FREDERICK COUNTY PLANNING COMMISSION

TITLE: Green Valley Farm, Section I, Lots 1-4

FILE NUMBER: M-2923, AP 14538 (APFO N/A, FRO 14819)

REQUEST: **Sketch Plan (Non-Binding Approval)**
The Applicant is requesting non-binding Sketch Plan approval for a 4-lot Agricultural subdivision on a 3,900 foot long dead-end road system.

Sketch Plan Layout

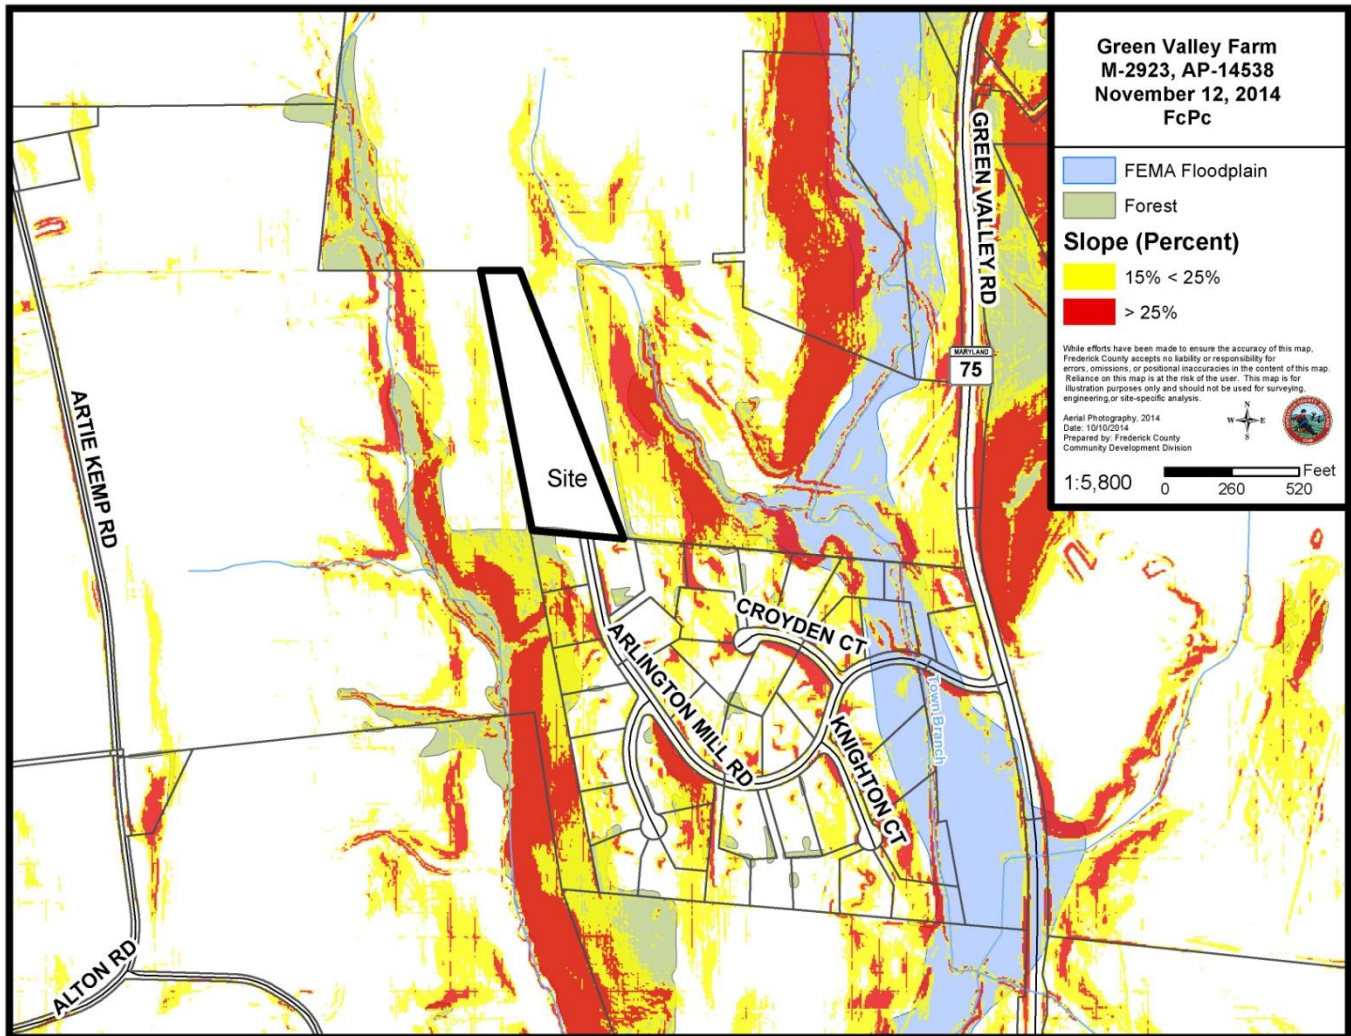
Staff has concerns with the proposed subdivision accessing Arlington Mill Road. Arlington Mill Road crosses a 100 year FEMA floodplain near the intersection with MD 75 (the area between road stations 2+00 and 5+50). According to the Applicant's surveyor the stream crossing is at an elevation of 402 feet, while the approximate flood elevation is 400.50 feet, a difference of only 1.5 feet. Environmental barriers such as this floodplain, as well as falling trees, utility poles, weather events, or vehicular accidents could limit residential and emergency services accessibility in and out of the development. Although this is an existing condition, increasing the number of dwelling units on the dead end street increases the potential safety risks and access concerns.

Although only 4 new lots are proposed to be added at this time, Staff is concerned that development of one or more of the other existing parcels of this farm could be proposed in the future. Access to Arlington Mill Road could be proposed as part of future parcel development, with the potential of 11 additional lots being added to the dead-end road system. The Applicant's first submittal of this plan proposed extending Arlington Mill Road 700 feet into the subject parcel, with a presumed intent to add even more lots to the dead end road at some point in the future. In response to Staff concerns the Applicant submitted the current Sketch Plan layout with only a 70 foot extension of the road, enough to facilitate the construction of a cul-de-sac bulb. In addition, the Applicant has added a note to the sketch plan stating "no additional lots from this farm will utilize Arlington Mill Road." Should the FcPc give a favorable opinion of this Sketch Plan, Staff recommends adding a condition to the approval in order to document this limitation.

There are some benefits to utilizing the proposed access onto Arlington Mill Road. Access directly from MD 75 to the proposed lots would require long panhandles (1,400-1,500 feet long) and a long common driveway that would require a stream crossing, removal of existing forest, and disturbance to wetlands and floodplain. Also, the Applicant is proposing to improve Arlington Mill Road with a cul-de-sac bulb, providing a much better turnaround for school busses, delivery vehicles, snow plows, and other users of the road.

2. The FRO plan must be approved, and FRO mitigation must be provided prior to lot recordation, grading permits, or building permits, whichever is applied for first.
3. No further subdivision of this farm shall be permitted to access Arlington Mill Road.
4. The Applicant shall submit a Preliminary Plan to the Planning Commission in the future to obtain approval of the proposed road extension and a modification of §1-16-236(K) to permit new lots in the Ag zone on a dead-end road that exceeds 1,800 feet in length and that serves more than 30 lots.
5. The common driveway must be constructed (minimum 12 foot width) prior to lot recordation in accordance with §1-16-109(D)(8).
6. The purchasers of the panhandle lots (2-4) are to be notified of the responsibilities of maintaining the common driveway.

Environmental Features

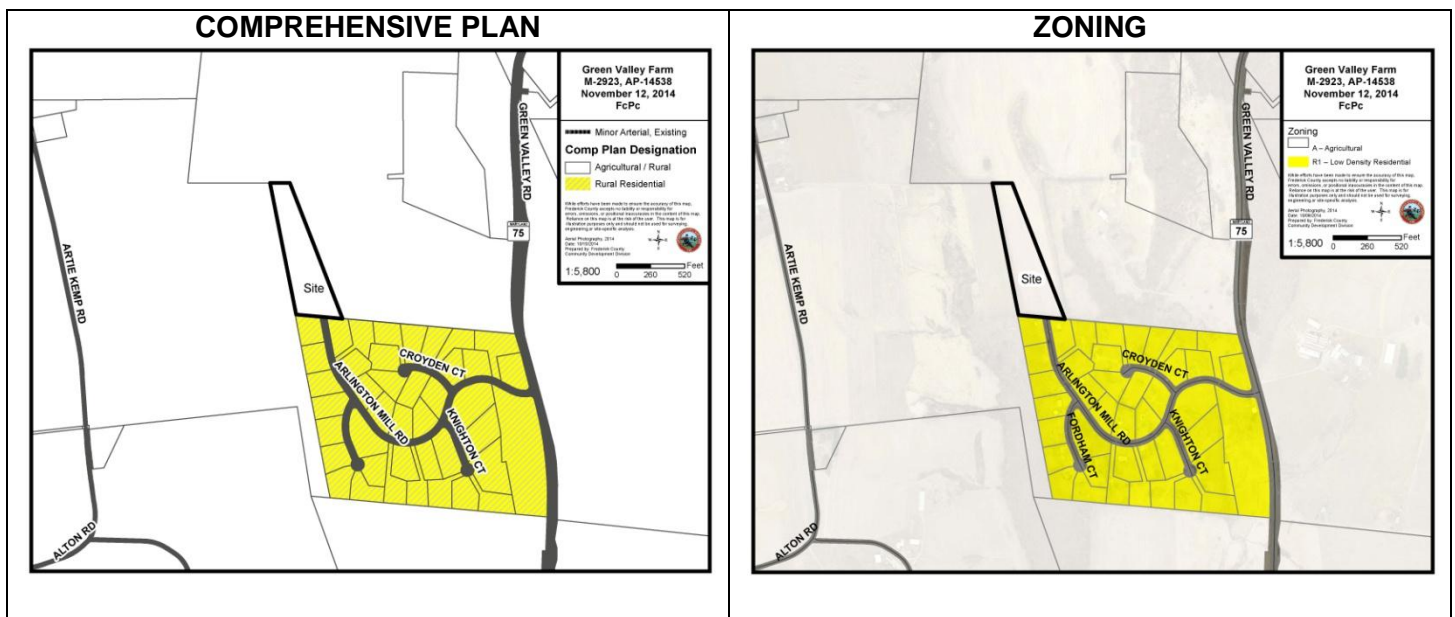
As noted earlier in this report, access directly from MD 75 would require long panhandles and a long common driveway that would require a stream crossing, removal of existing forest, and disturbance to wetlands and floodplain. The proposal to utilize Arlington Mill Road would eliminate all environmental impacts.
